Maserati Technical Bulletin

Bulletin No. MASO00XXX Safety Recall 300

MODEL: Maserati Granturismo & Granturismo Convertible

SUBJECT: Vehicle Safety Recall No. 300, Main Fuel Delivery Line replacement

Fig.2

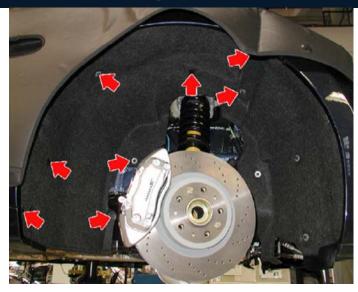
- 2. Remove the right side front wheel.
- 3. Remove the fasteners on the inner wheel well panel. (Red arrows, Fig.2)
